2. COA-052438-2019

Commission of Architectural Review

STAFF REPORT

Repair roof, adding copper coping and cladding to stepped parapet walls.

Figure 1. 2300 Monument Avenue ca. 1920

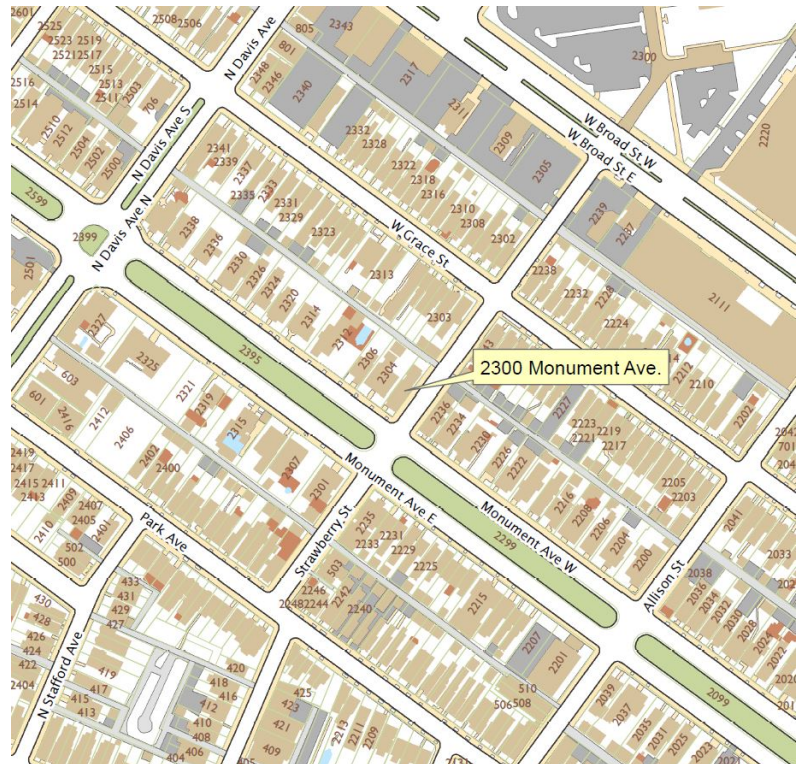
The home historically did not have any copper coping, which tends to be a decorative element indicative of more eclectic styles. Staff has located a photograph of the house dating from the 1920s which shows the brick parapet walls had no coping. In addition, other parapet walls on nearby buildings also do not have any coping. The addition of a significant amount of a new material that was not historically present and that would be highly visible is not consistent with the *Guidelines* and staff recommends denial of the installation of copper on the parapet walls.

- Staff recommends **denial** of the installation of copper on the parapet walls.
